ADDENDUM NO. 1

Date of Addendum: 9/17/15

PROJECT NAME: Keegans Bayou WWTP Improvements

PROJECT NO: WBS No. R-000265-0101-4

ELECTRICAL
SITE PLAN – 1

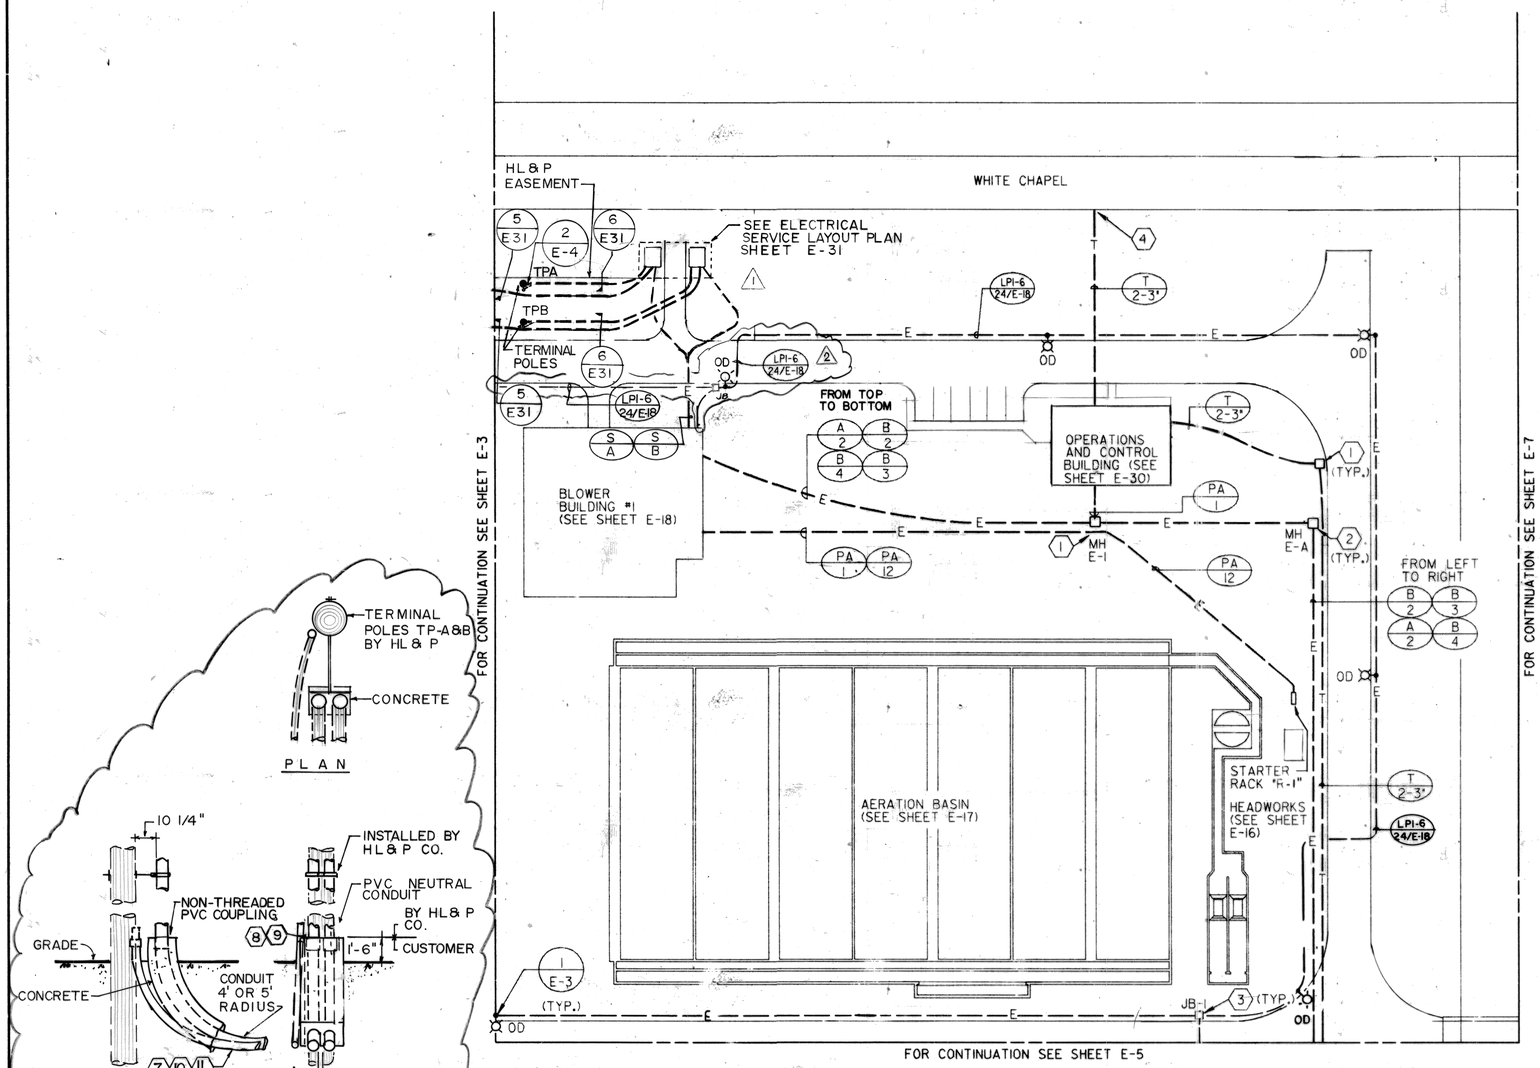
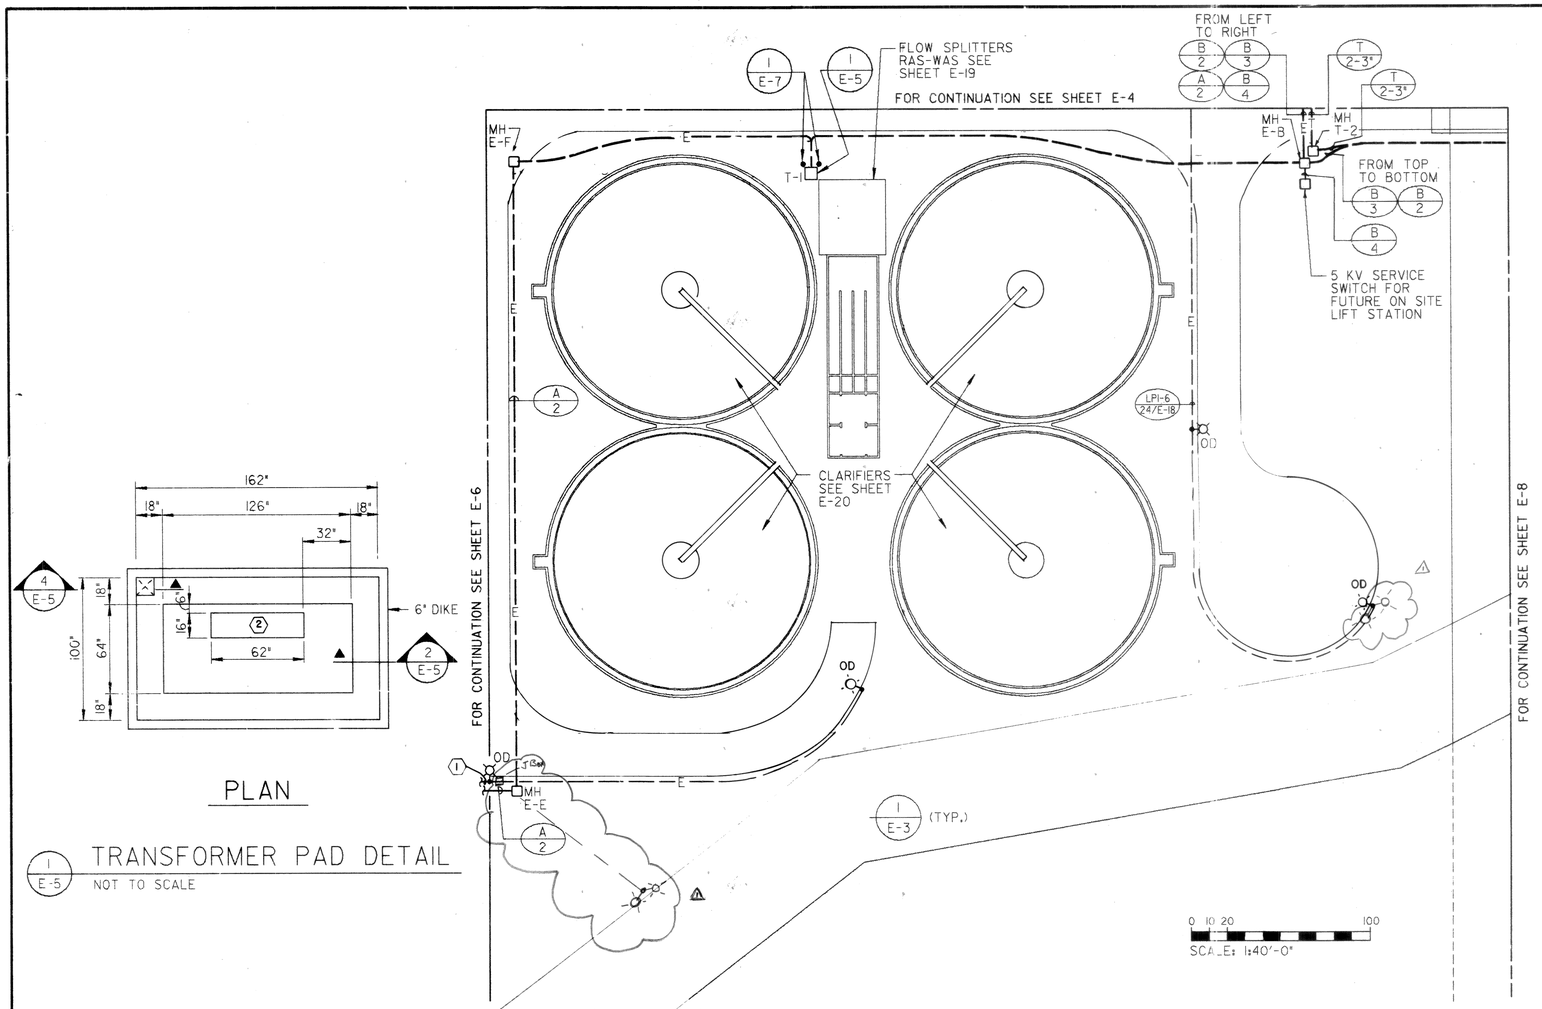
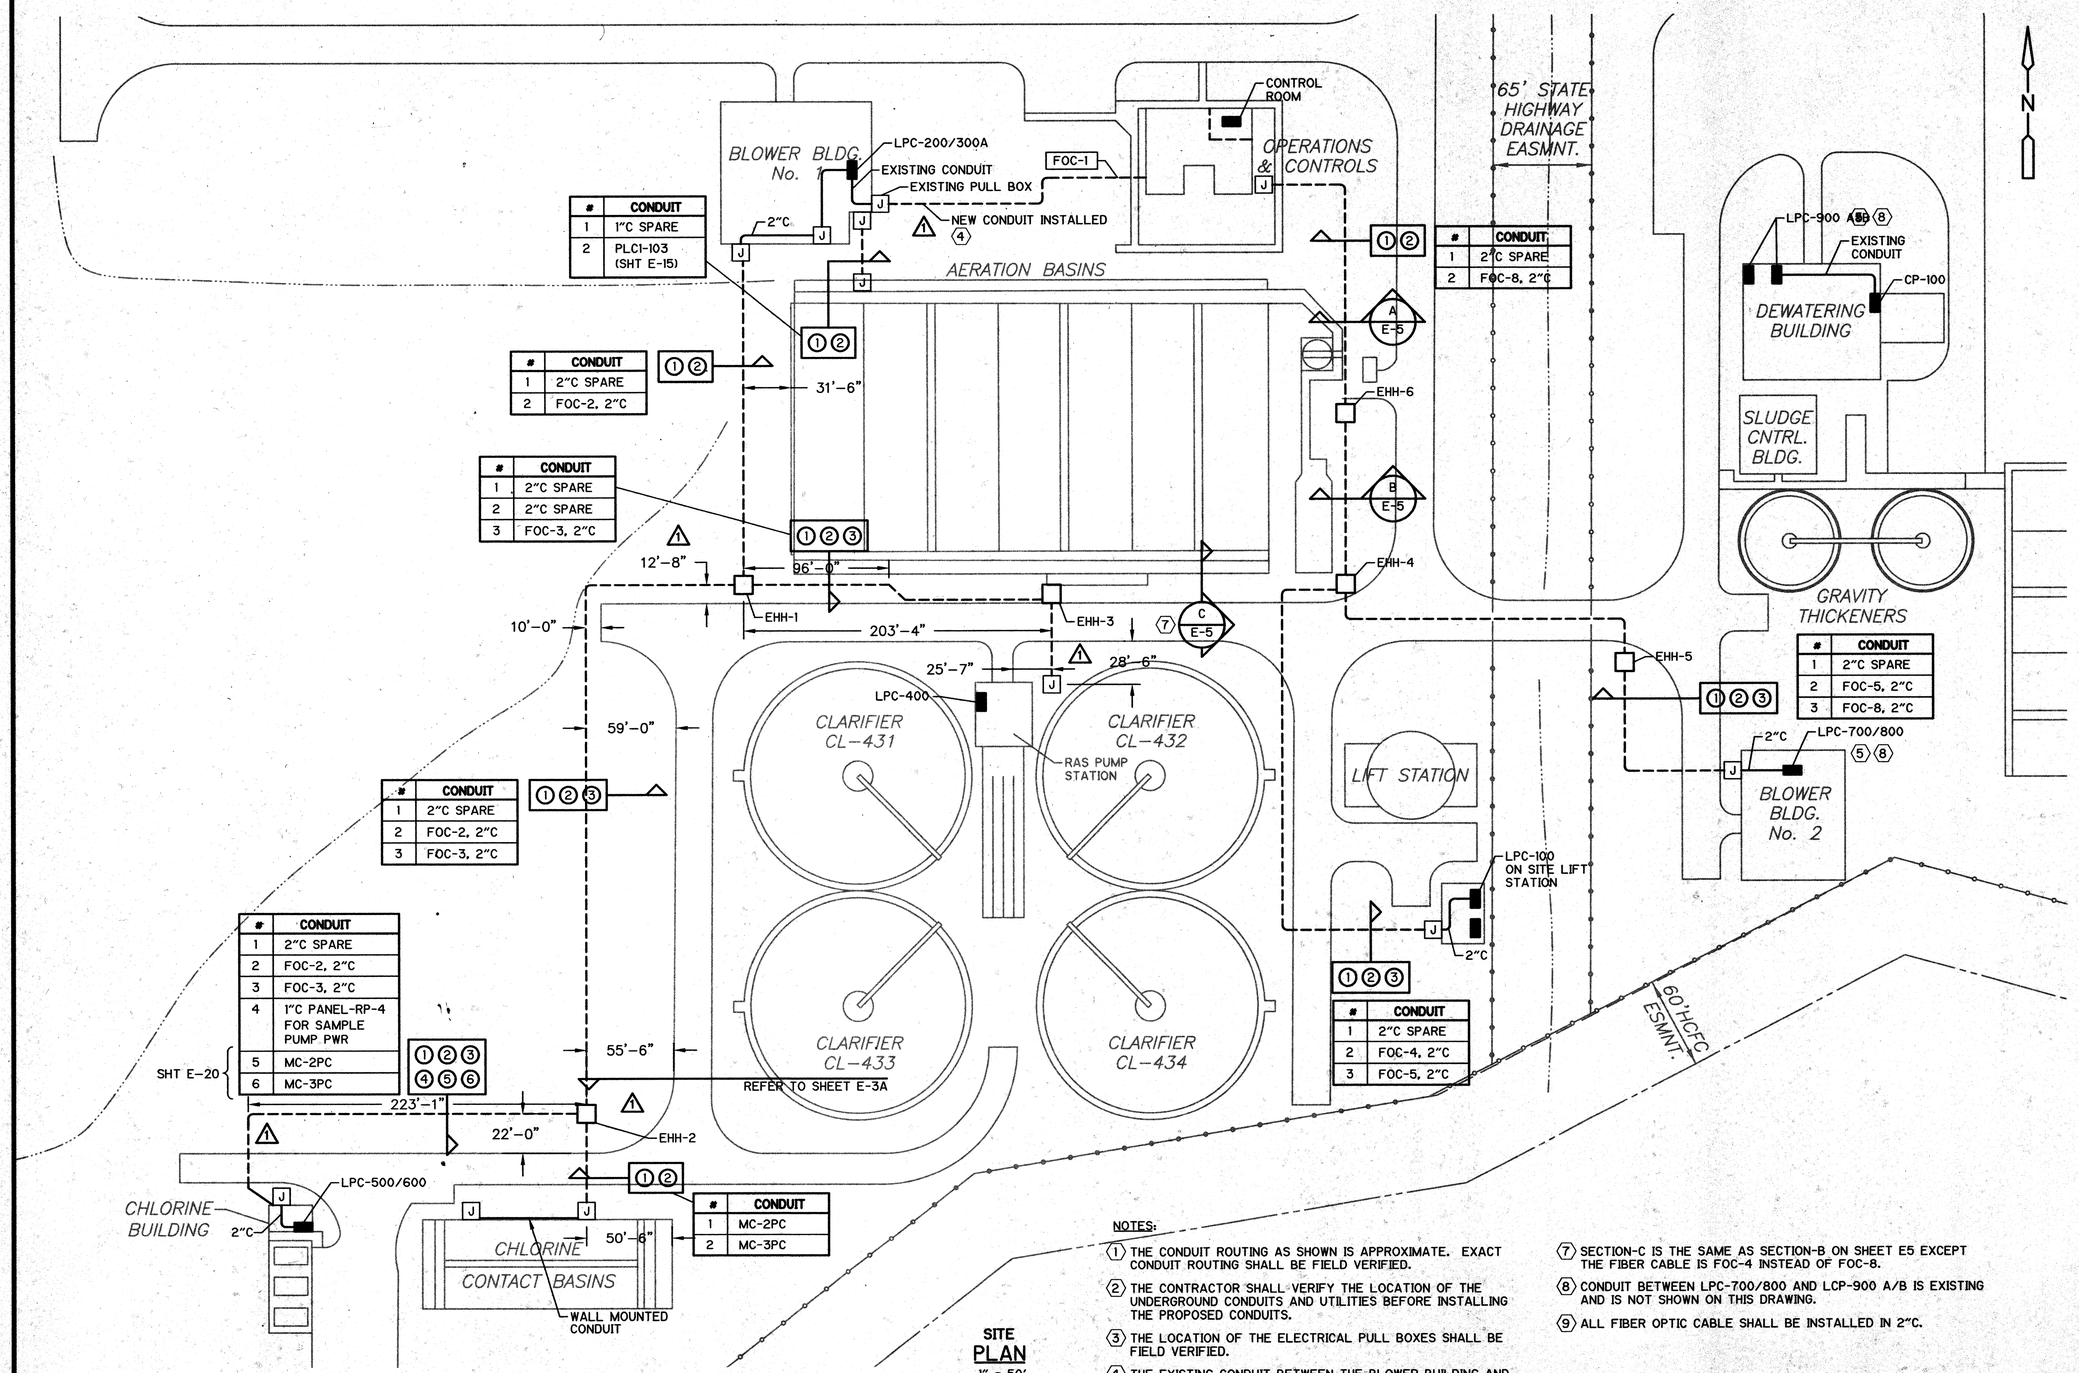
59. Question: Sheet 39: can electrical as-builts be provided for the areas along the proposed 30" sludge force main routing? Answer: See attached electrical site plan as-built drawings.
